Site Accessibility Evaluation

Americans with Disabilities Act Title II (Public Services: State and Local Government)

Centennial Hall

Accessibility Evaluation

Finding: 1

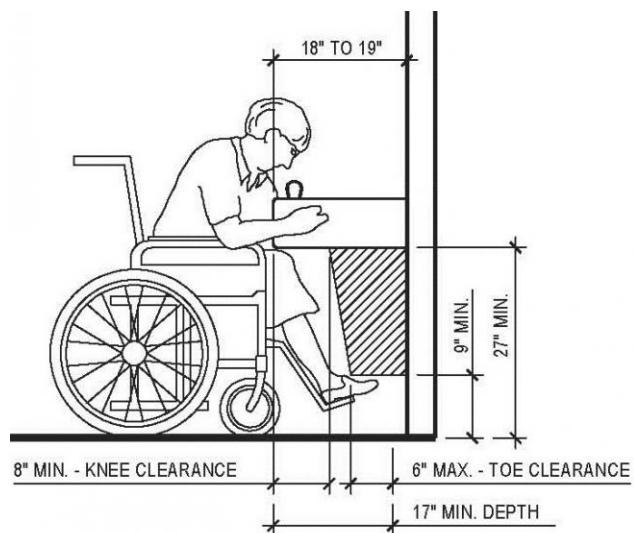
There is not enough knee clearance under the drinking fountain.

The drinking fountain must have a clear knee space between the bottom of the drinking fountain and the floor not less than 27 inches in height, 30 inches in width, and 8 inches in depth.

2010 ADAS Section 602.2

Bottom edge of
drinking fountain at
26.5 inches

Adjust drinking fountain height to provide 27 inches of clearance.
